Department of Energy

95-DOE-08469

Responses to Colorado Department of Public Health and Environment Comments on the CDPHE Conservative Screen Letter Report for OU 3

Figure 1. Trench 03492

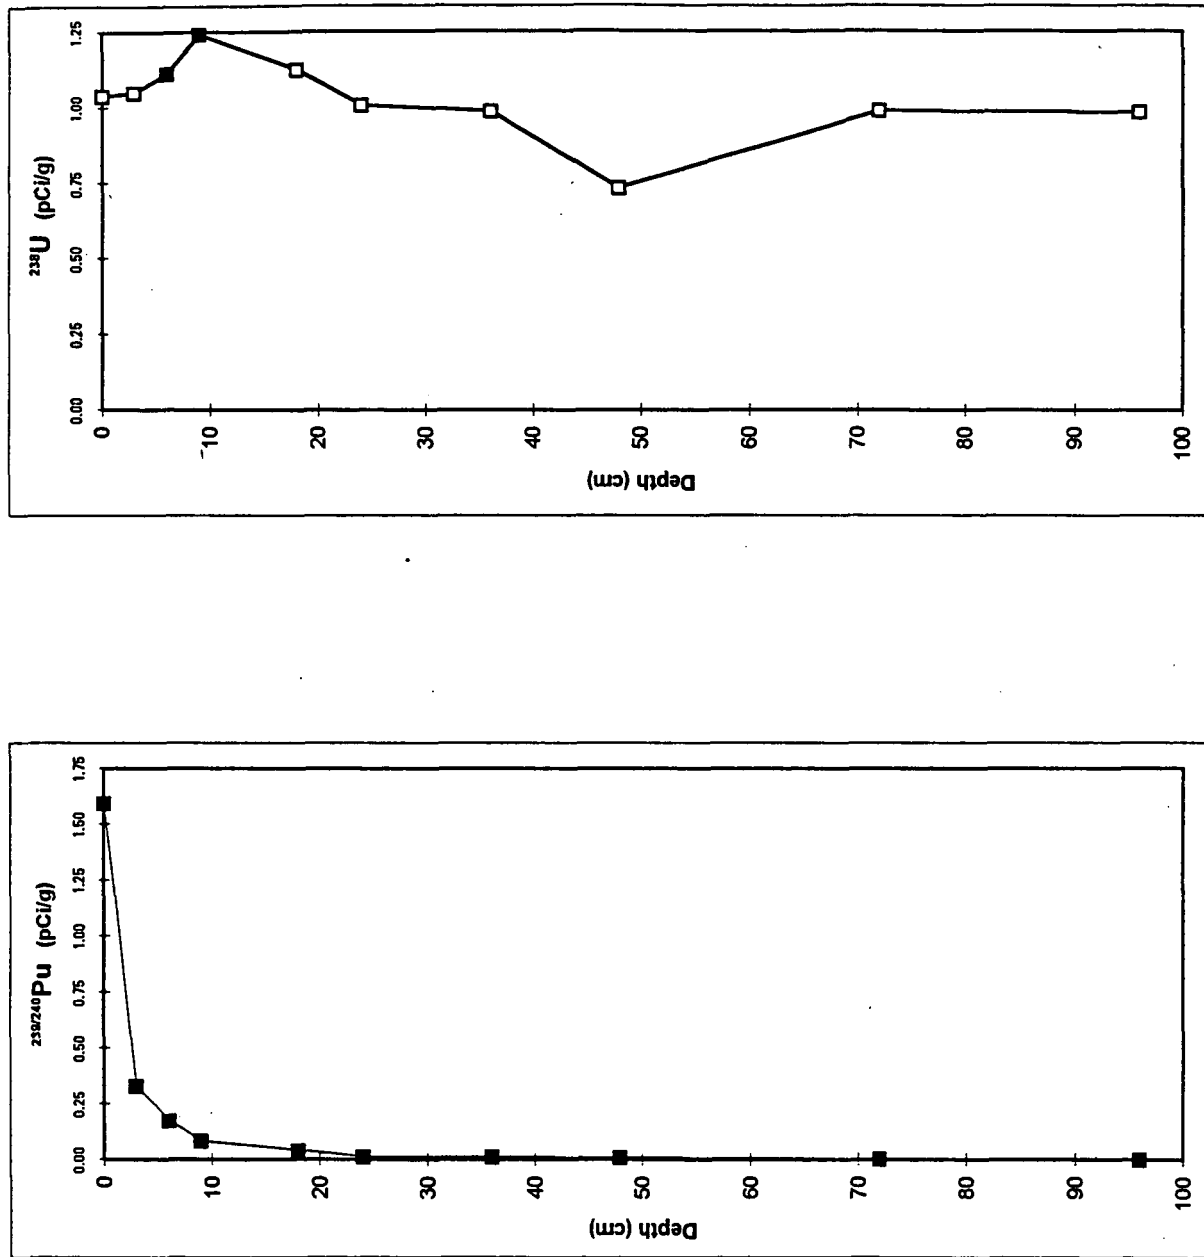
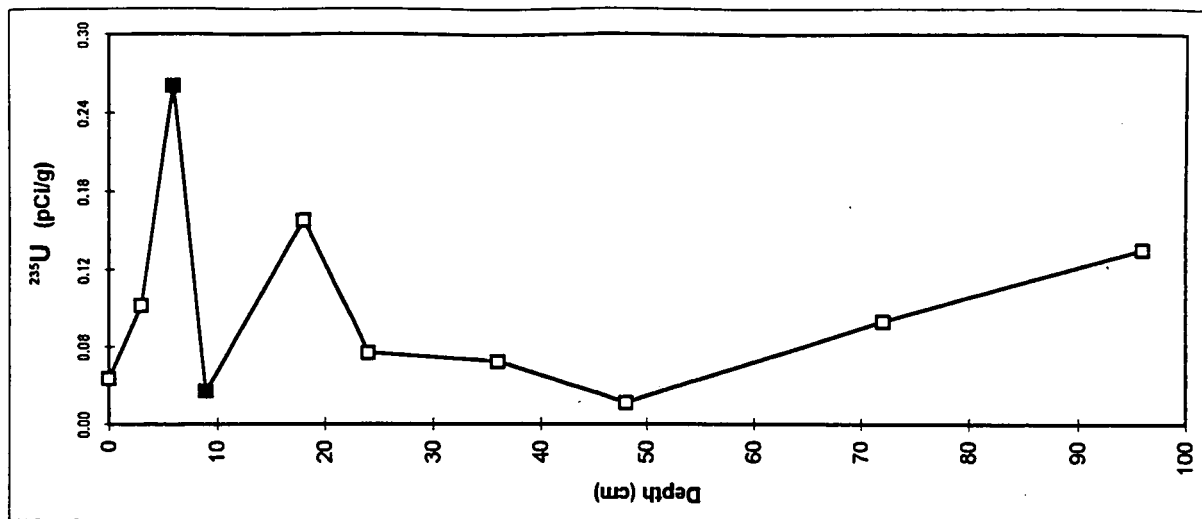
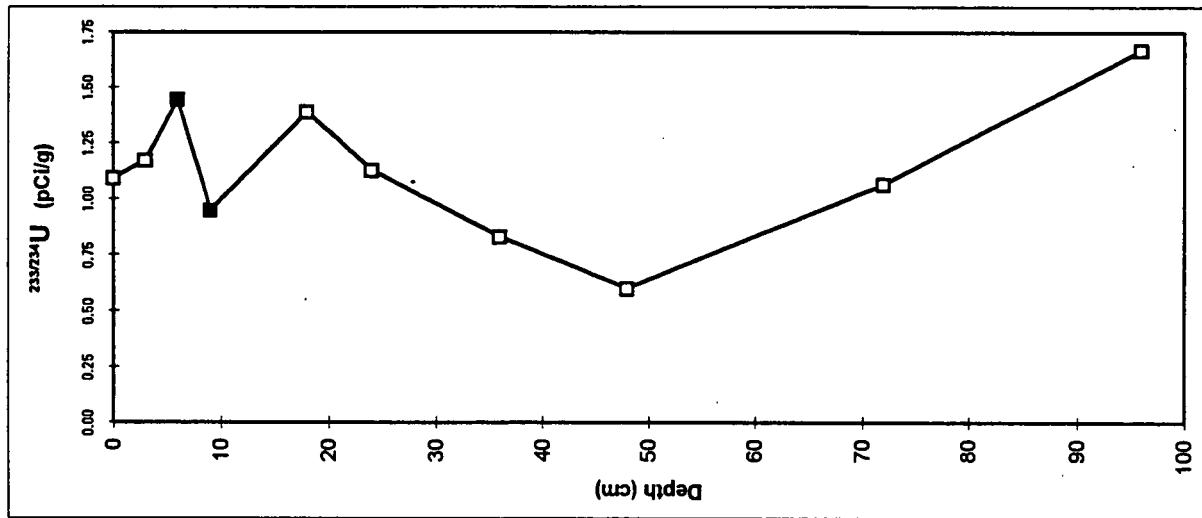
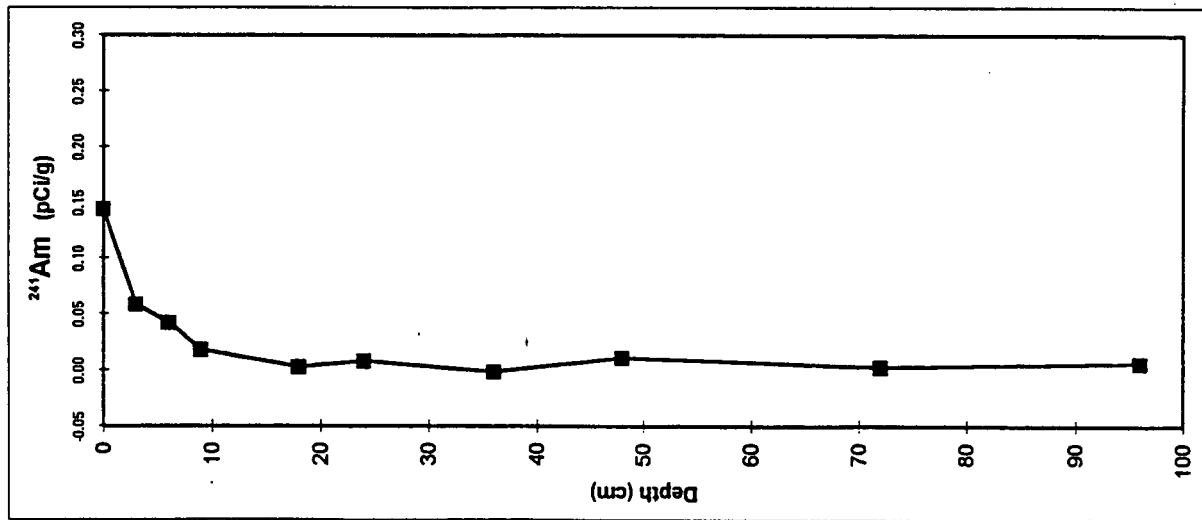
Verify that activities for uranium isotopes are at background levels. Four of the five statistical comparison tests indicate that the levels of uranium isotopes in OU 3 subsurface soil are not significantly different than background levels (Tables 1 and 2). Results of one test, the Upper Tolerance Limit (UTL) test (also referred to as the Hot-Measurement test) indicate that the uranium isotopes may be PCOCs. However, after further analysis of the levels and

Only four samples in two of the trenches have activities of uranium that exceed UTLs for background soil. Trench TR03492, located in the southern parcel of the Jefferson County Remedy Acres, has one UTL exceedance for ^{235}U at a depth of 6 inches. The ^{235}U activity for this sample is 0.26 pCi/g and the UTL for ^{235}U is 0.199 pCi/g. Trench TR03692, located directly north of the southern parcel of the Jefferson County Remedy Acres and west of Mower Reservoir, has exceedances of the UTLs for $^{233/234}\text{U}$ at a depth of 3 inches, ^{235}U at a depth of 96 inches, and ^{238}U at a depth of 3 inches. Table 4 summarizes the activities and the UTLs for the uranium isotopes for the four samples where UTLs are exceeded.

Figures 1 and 2 show radionuclide activities with depth for the soil trenches TR03492 and TR03692. Activities for ^{241}Am and $^{239/240}\text{Pu}$ are greatest at the surface, with activities decreasing with depth to less than 0.01 pCi/g for ^{241}Am and 0.10 pCi/g for $^{239/240}\text{Pu}$ at a depth of about 10 centimeters. These subsurface soil depth profiles indicate that the presence of ^{241}Am and $^{239/240}\text{Pu}$ in OU 3 soil is the result of windblown deposition. Activities of the uranium isotopes show a different pattern, with levels of activities of $^{233/234}\text{U}$, ^{235}U , and ^{238}U varying over the entire depth of the trench samples at one location. The distribution of activities with depth for the uranium isotopes indicates variability associated with background conditions rather than wind-blown contamination from the Site. (Note: The majority of the uranium data for TR03492 were rejected by the independent data validators. These rejected data for TR03492 appear to follow the same pattern as TR03692 so they are included to show the complete depth profile.) Based on the analysis of levels and patterns of uranium activities in subsurface soil, $^{233/234}\text{U}$, ^{235}U , and ^{238}U were not retained as PCOCs for the CDPHE Conservative Screen. These analytes were also eliminated as PCOCs for soil based on analysis of the surface soil data set (see Section 2.3.1 of the CDPHE Letter Report for OU 3, September 23, 1994).

Figure 3
Distribution of Arsenic
in Sediments and Soils

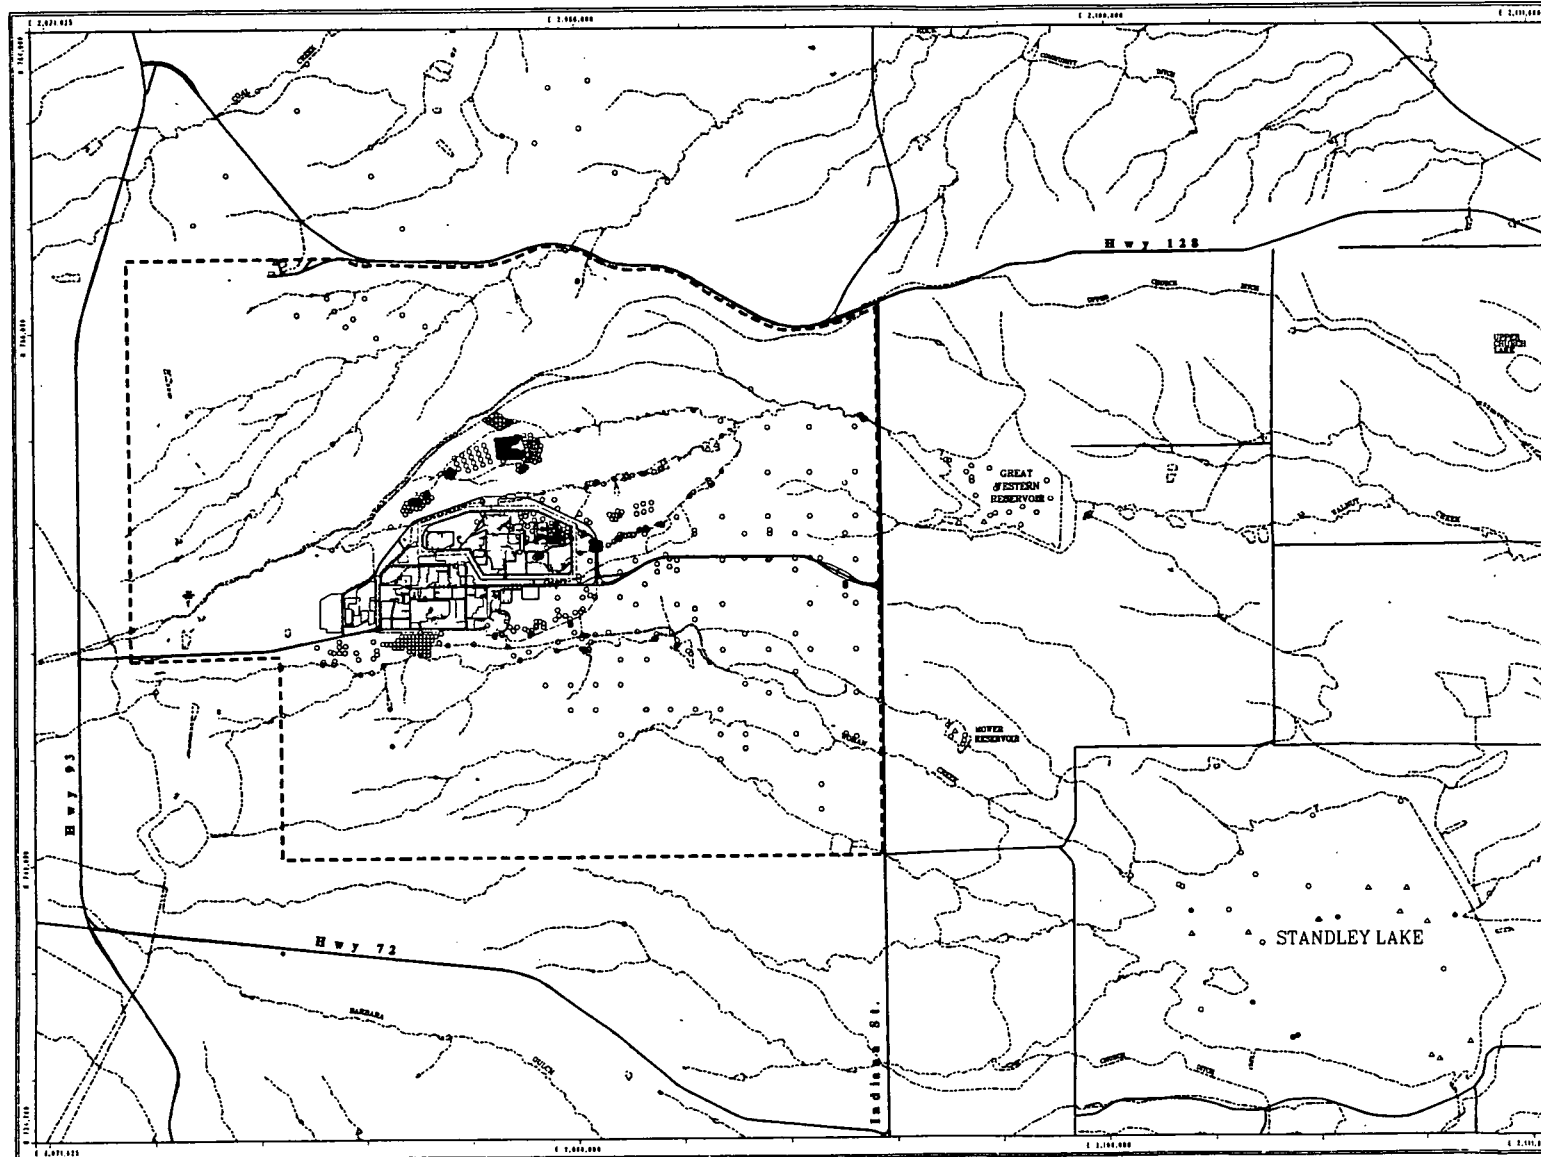
Step 2. Perform a spatial analysis for each metal analyte identified in Step 1. The spatial analysis will be presented on an 11 x 17 inch map that shows concentrations of metal analytes over the entire Site, including OU 3. Any metals that do not appear to be Site-related will be eliminated as PCOCs.

Figures 3 through 9 are maps that show site-wide concentrations of metals not eliminated as PCOCs by Step 1 described above (i.e., arsenic, cadmium, copper, lead, nickel, potassium, and zinc for Standley Lake and potassium for Mower Reservoir). For core samples in the reservoirs, the maximum value at each location is shown on the maps.

For the metal analytes shown on Figures 3 through 9, the majority of the samples collected within the Site boundaries and from OU 3 have concentrations below stream sediment UTLs reported in the Background Geochemical Characterization Report (DOE, 1993). In general, the highest concentrations for these metals tend to be in the deeper areas of Standley Lake. Natural limnological phenomena explain the slightly elevated concentrations of metals in the center of the reservoirs. The finer particles of sediment tend to have the highest concentrations of organic matter, and thus higher metal concentrations associated with the organic matter (Davis and Kent, 1990). These finer sediment particles in the water column also tend to deposit in the center of the lake where flow velocities can no longer support particle suspension.
